# William Hilton Parkway Gateway Corridor Independent Review Council Workshop

*June 17<sup>th</sup>, 2024*

# New Bridge vs. Rehabilitation

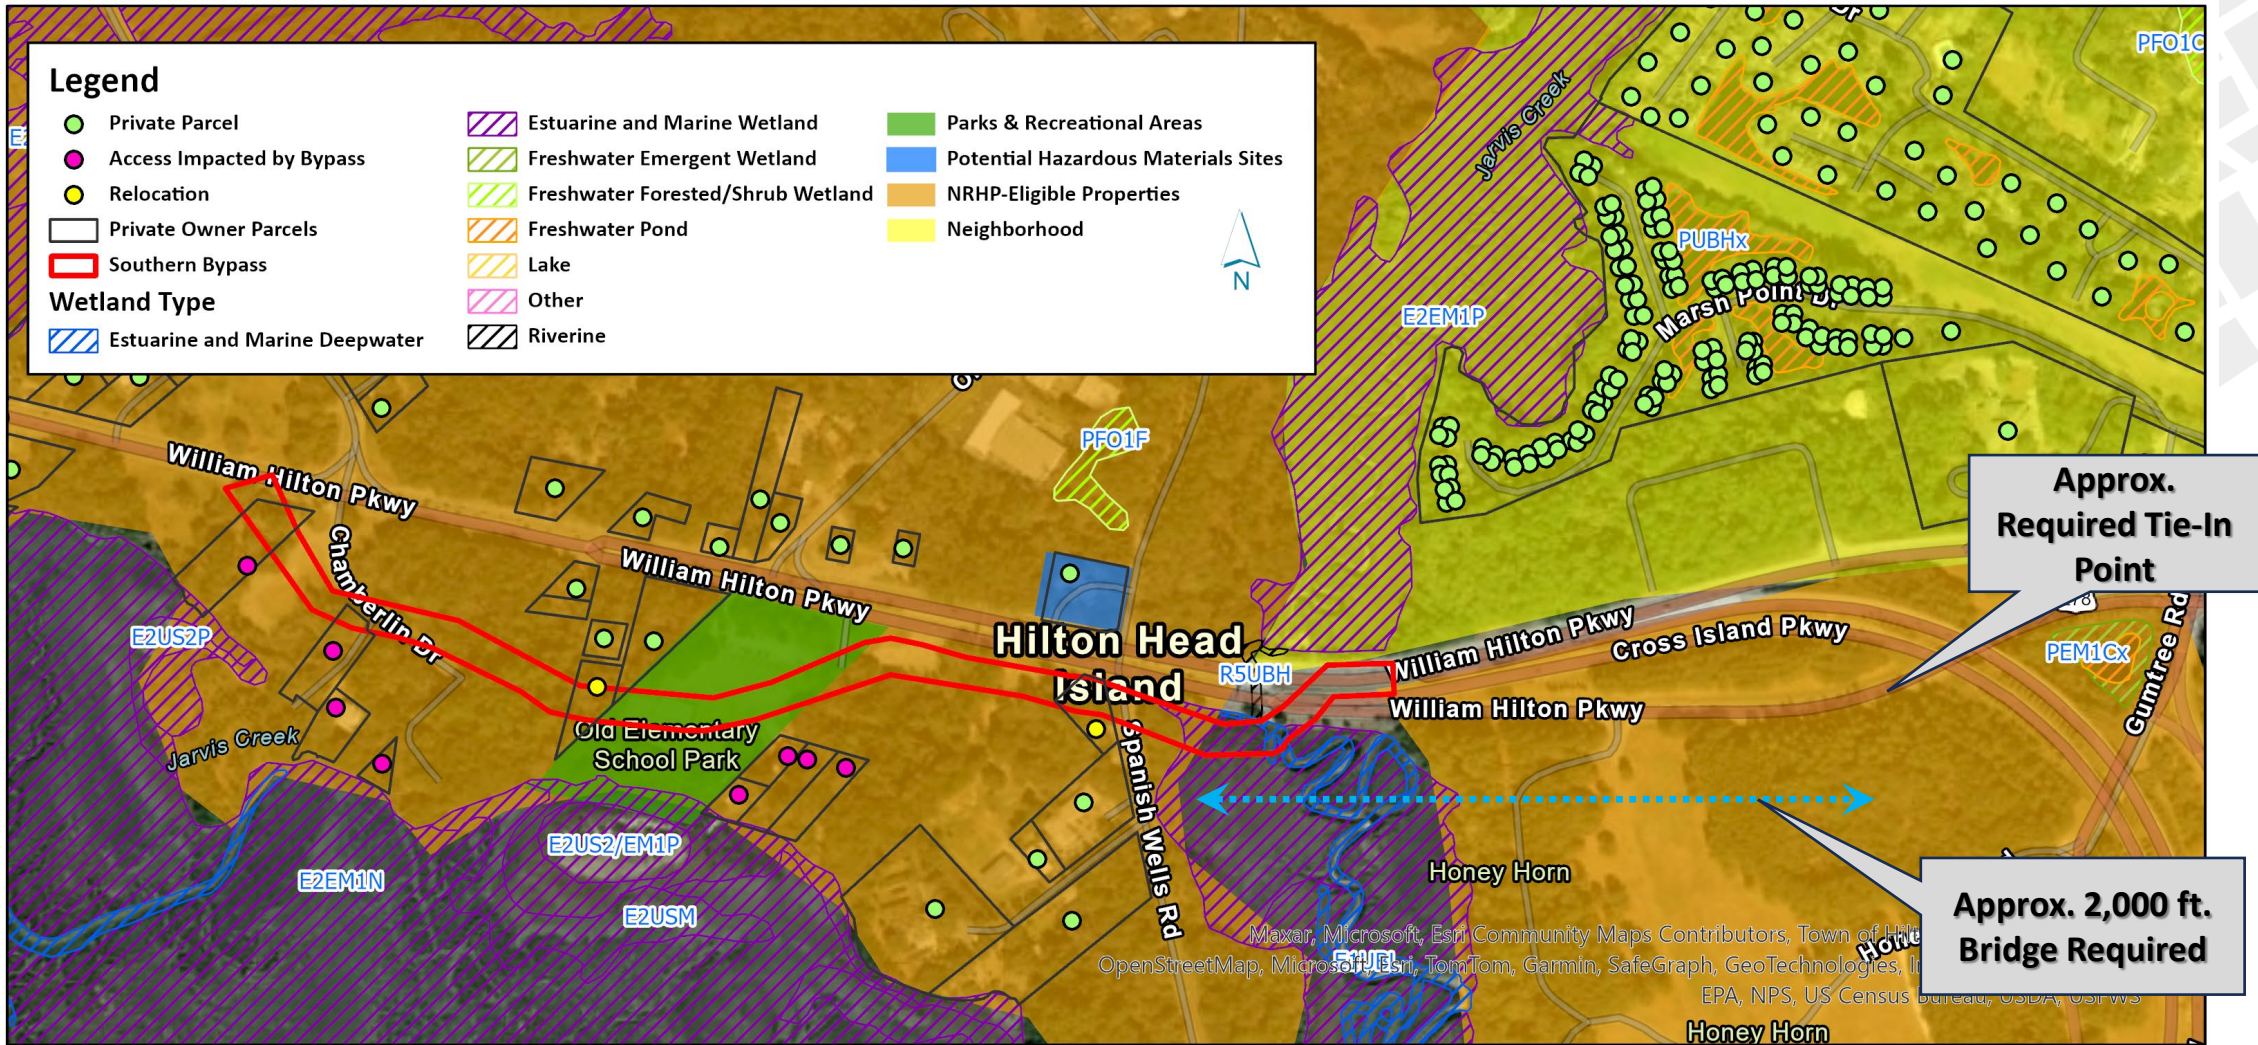
- The SCDOT Design Team's structural analysis findings; LCCA results; and noted benefits/risks with Options 1/2/3 appear valid and appear to follow standard engineering practices.

- The LCCA results do not account for costs that would be required to improve seismic conditions for Options 1 & 2. Therefore, **true costs associated with Options 1 & 2 would be significantly higher to implement, than what is shown in the LCCA table.**

- Options 1 & 2 would take approximately 2 years longer to construct vs Option 3. **The rehabilitated structures would still need to be replaced at some point, and time required to do so is not accounted for in this table.**

- Existing bridge structures would be approximately 50 years old after improvements made by Options 1 or 2, with rehab efforts likely to extend life of existing structures by approximately 25 to 35 years. By comparison, **typical design life for Option 3 newly constructed bridges approximately 75 to 100 years.**

- **Options 1 & 2** being pursued for use solely as temporary condition would require more than \$130M to construct initially (using 2020 costs), and **these costs do not account for needed Functional Evaluation Earthquake (FEE) seismic design improvements.** Depending upon when remaining structures were replaced, the future/user/maintenance costs req'd over that time would assuredly lead to higher overall cost than building new at outset.

- **Options 1 & 2** would put maintenance/replacement schedules of the structures on varying timeframes, which **would cause additional user disruptions in the future.**

- **Existing structures under Options 1 & 2 would never meet Safety Evaluation Earthquake (SEE) seismic design requirements.** New structures can be built to meet SEE seismic design requirements.

- In summary, Lochmueller does not recommend rehabilitation and/or retrofit options being pursued for this project, in lieu of constructing a new six-lane bridge connecting Bluffton and Hilton Head Island.
